Fire Risk Assessment (V.3)

5 Great James Street, Bloomsbury, London

David Brown CMIOSH MIFireE
William Martin Compliance Solutions Limited
85 Gresham Street
London
EC2V 7NQ

Date of Site Visit: 19/01/2018

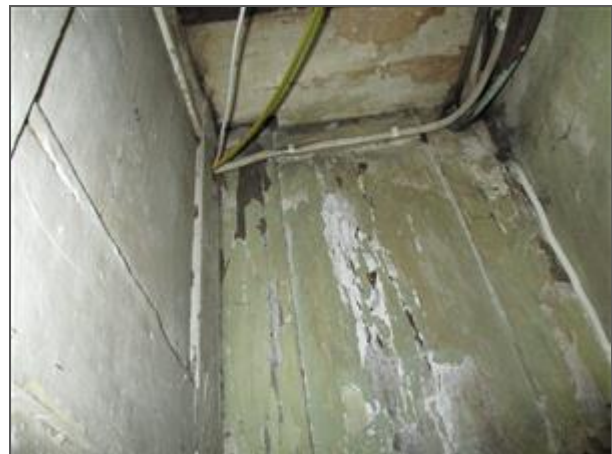
The fire separation between the basement and the ground floor is believed to be lathe and plaster which is not in good condition and only providing a notional 30 minutes fire resistance, this needs to be made up to 60 minutes fire resisting preferably by encapsulating in additional plaster board with the joints to be taped and the whole skimmed with plaster.

The fire separation between the basement and the ground floor is believed to be lathe and plaster which is not in good condition and only providing a notional 30 minutes fire resistance, this needs to be made up to 60 minutes fire resisting preferably by encapsulating in additional plaster board with the joints to be taped and the whole skimmed with plaster.

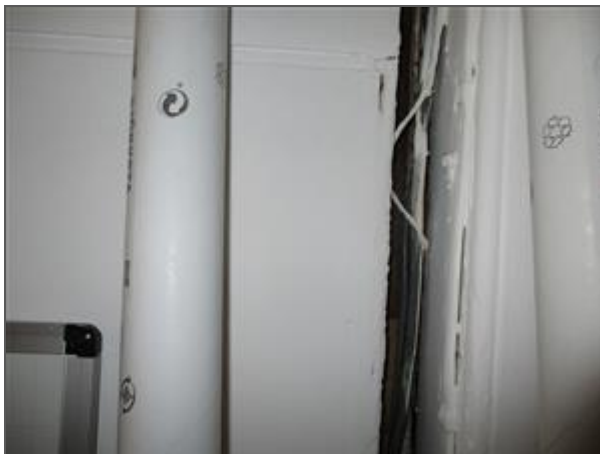
The penetrations in the basement cupboards adjacent to the basement means of escape to the front of the building by ducting or building services should be fire stopped using approved materials installed by a competent contractor to provide a minimum of 30 minutes fire resistance.

The penetrations in the basement cupboards adjacent to the basement means of escape to the front of the building by ducting or building services should be fire stopped using approved materials installed by a competent contractor to provide a minimum of 30 minutes fire resistance.

The unprotected wood in the cupboards adjacent to the basement means of escape to the front of the building that cannot be encapsulated should be treated with a fire retardant paint or varnish to provide 30 minutes fire resistance.

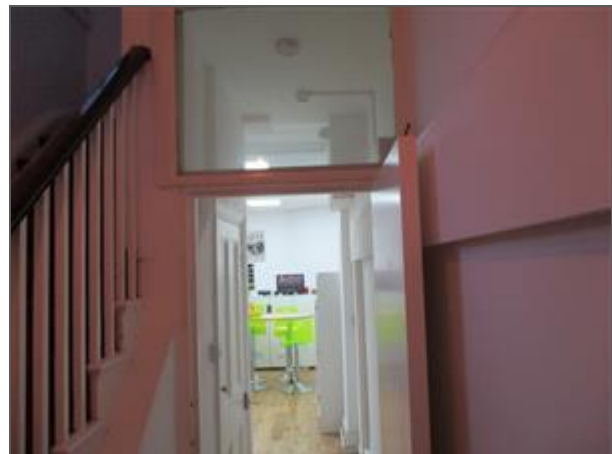
Ensure that the escape routes in the following areas are free from combustible material: On the staircase under the window.
